ADDENDUM NO. 1

PROJECT NAME: Legacy High School BB - SB Renovations

CLIENT NAME: Mansfield ISD

ADDENDUM DATE: Tuesday, April 29, 2025

DEMOLITION AND **EROSION CONTROL** PLAN

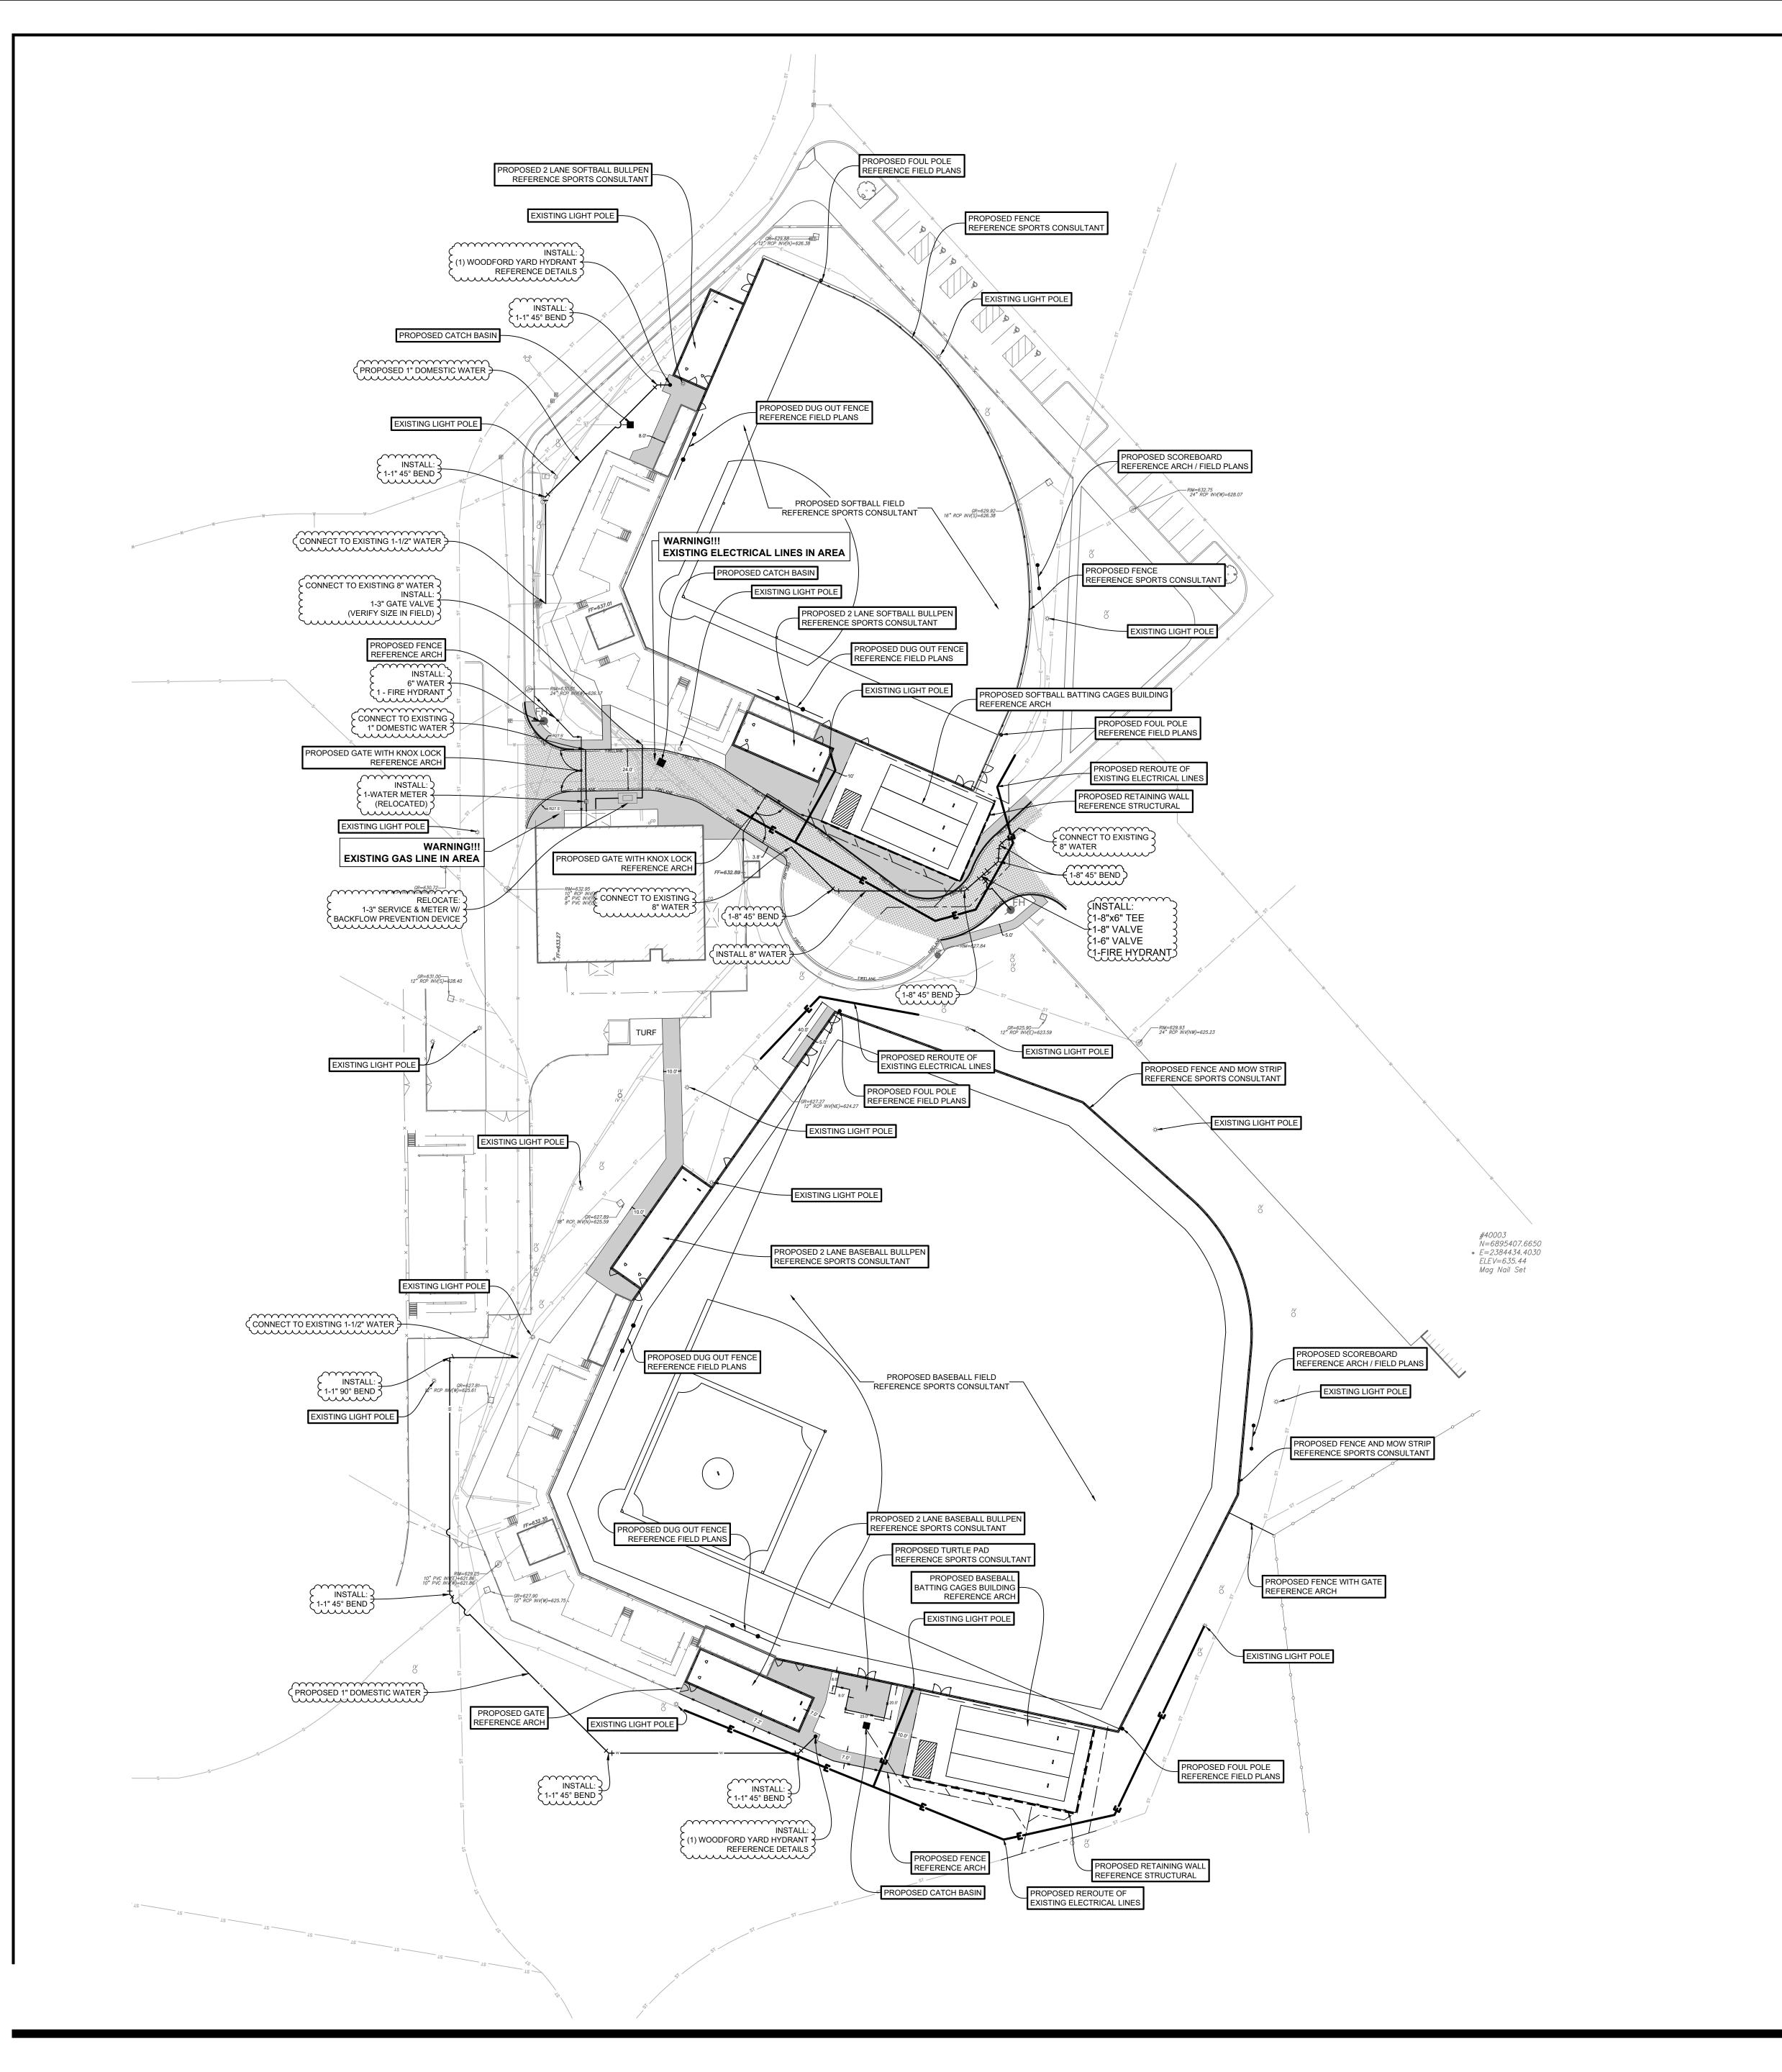
AD No 1, Civil Item 1: To the Drawings, Sheet C2.00, "DEMOLITION AND EROSION CONTROL PLAN,"

- 1) Underground utility linework was added to plan sheet for reference purposes and show possible conflict areas during construction. Limits of underground electrical to be relocated/removed were added to sheet.
- 2) Portion of storm sewer removal was revised to include section of sewer adjacent to 3rd base dugout on softball field.

AD No 1, Civil Item 2: To the Drawings, Sheet C2.00, "DEMOLITION AND EROSION CONTROL PLAN,"

For clarification, notes were added to match field plans that call for the removal of foul poles on both the baseball and softball fields. Warning label was added to notate location of existing gas and electrical lines north of the existing field house building.

FOUNDATION PLAN PACKAGE

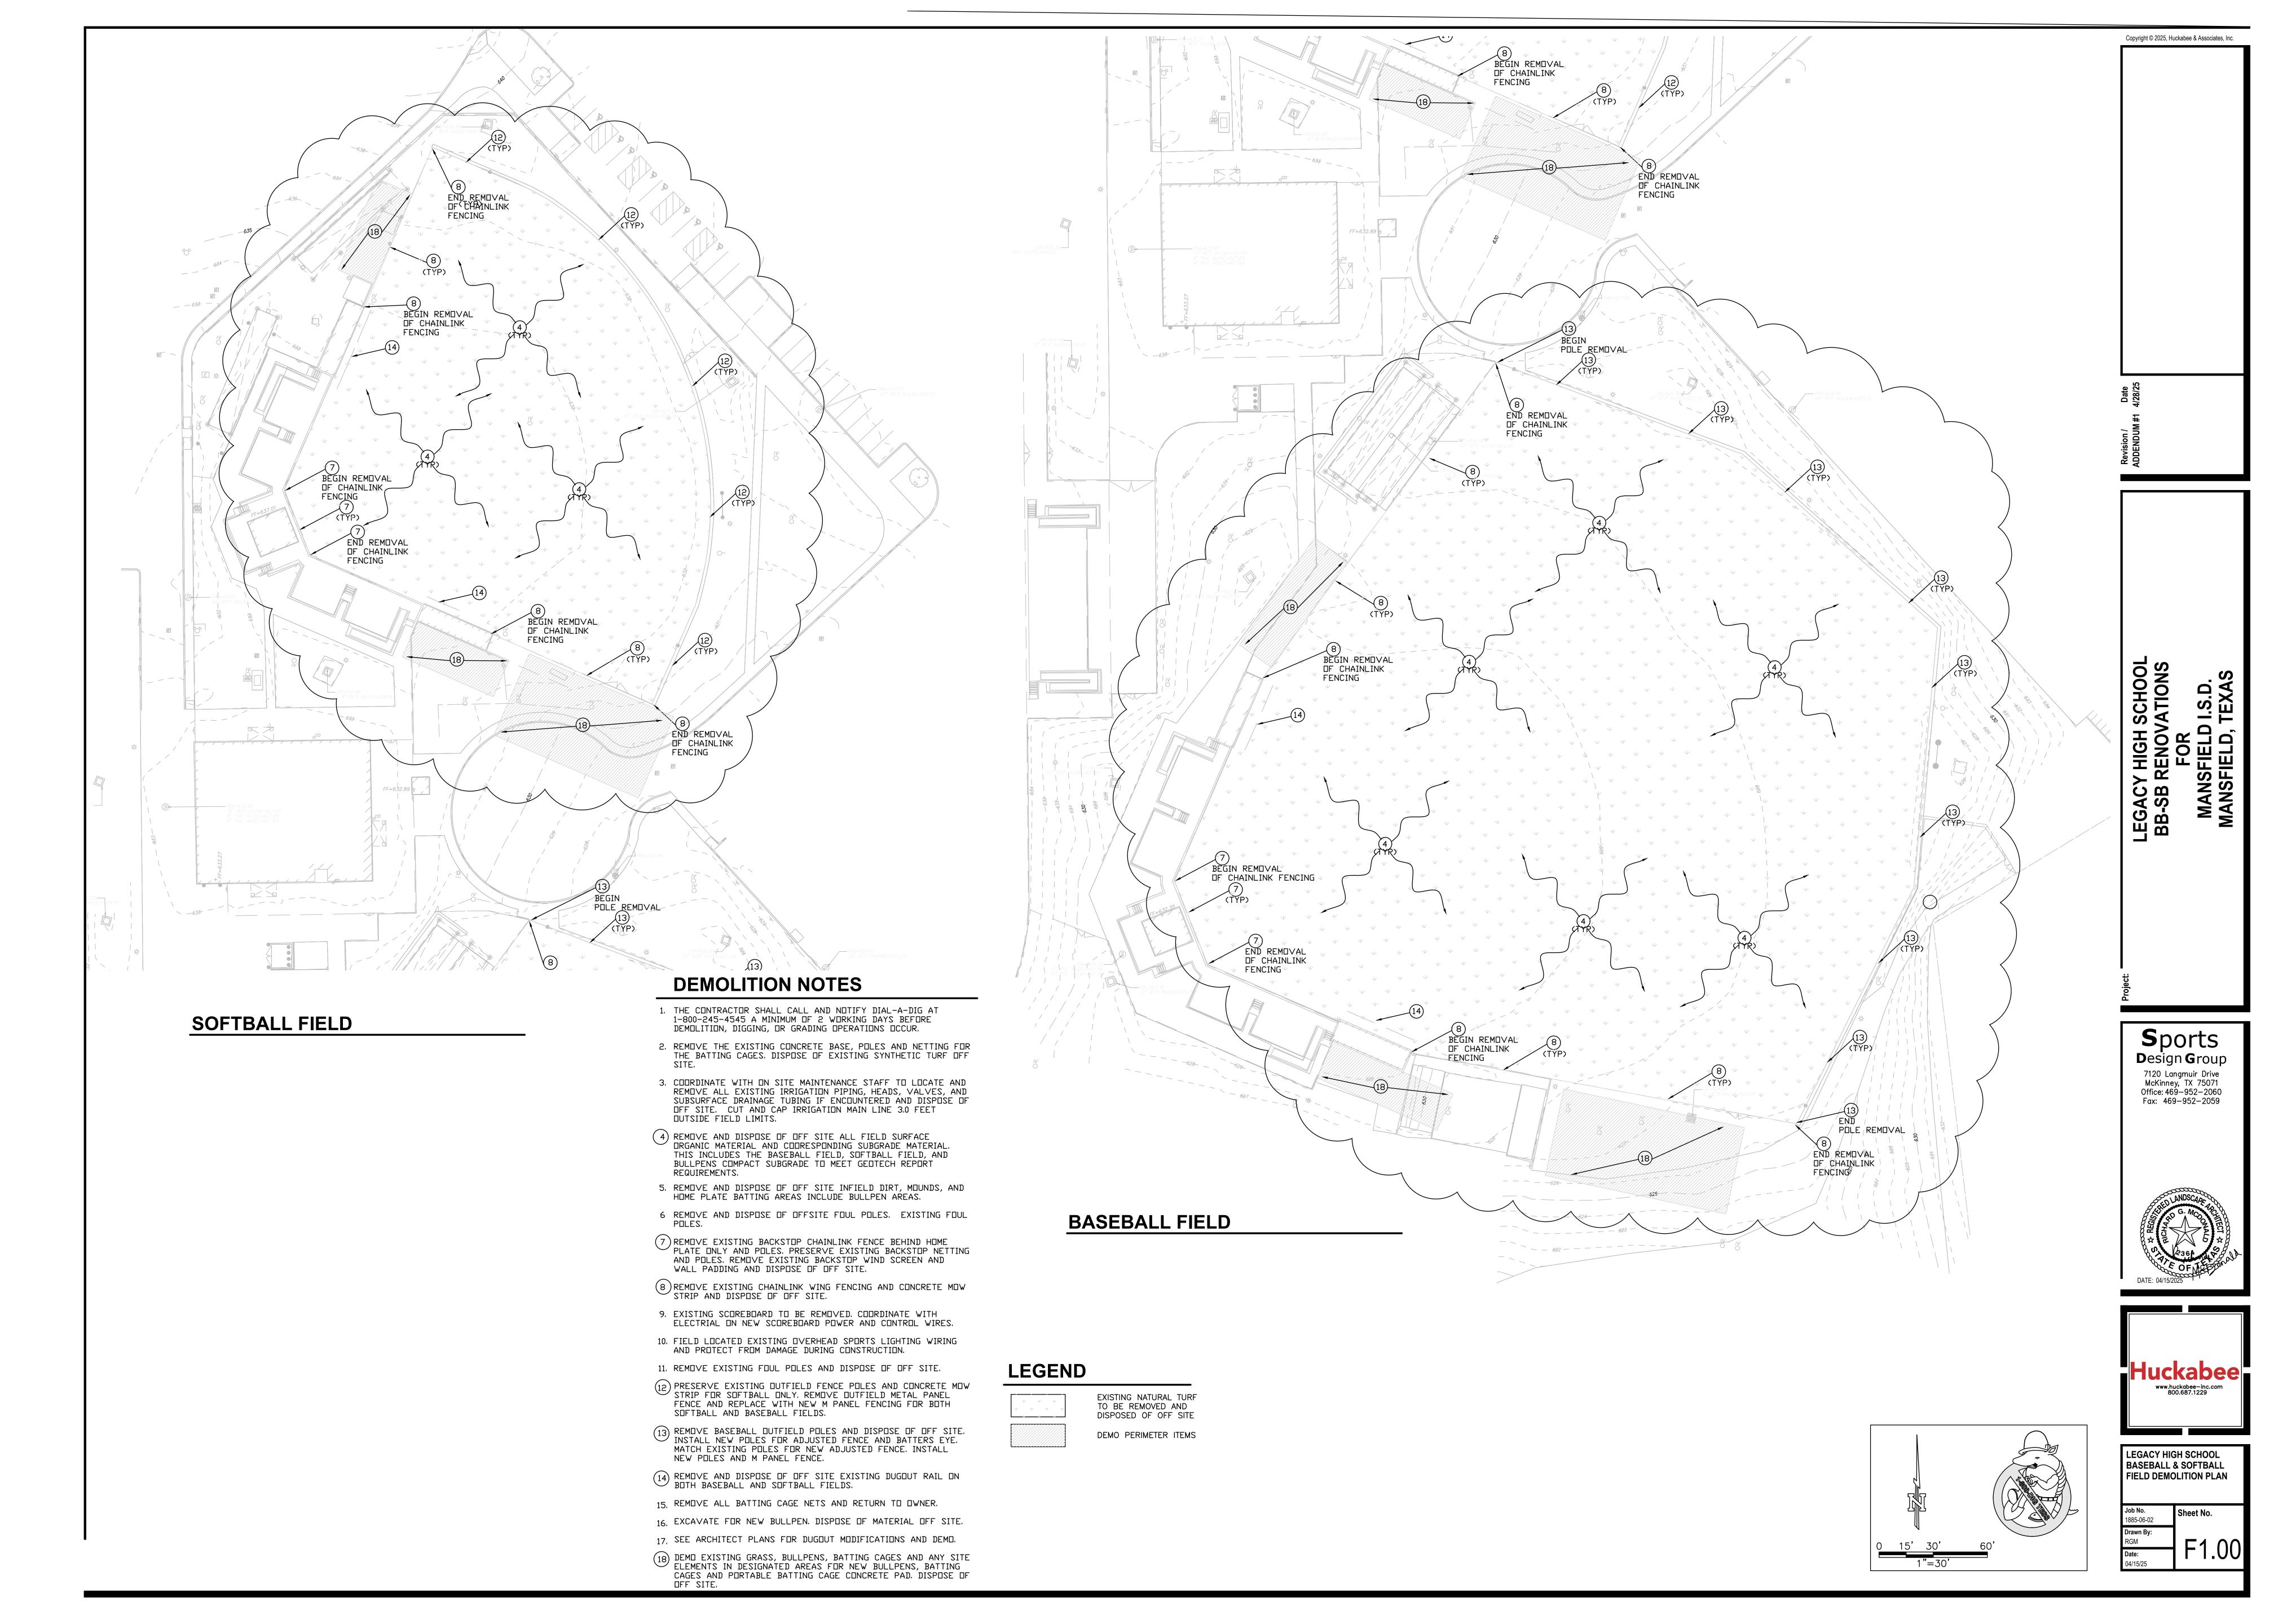
AD No 1, Struct Item 2: To the Drawings, Sheet S2.01,

- 1. Plan 1/S2.01: Revised footing/grade dimensions.
- 2. Plan 1/S2.01: Section 4/S3.01 was added.
- 3. Plan 2/S2.01: Revised footing/grade beam dimensions.
- 4. Plan 2/S2.01: Top of wall elevation and bottom of lintel elevations have been added.
- 5. Plan 2/S2.01: Section 4/S3.01 was added.
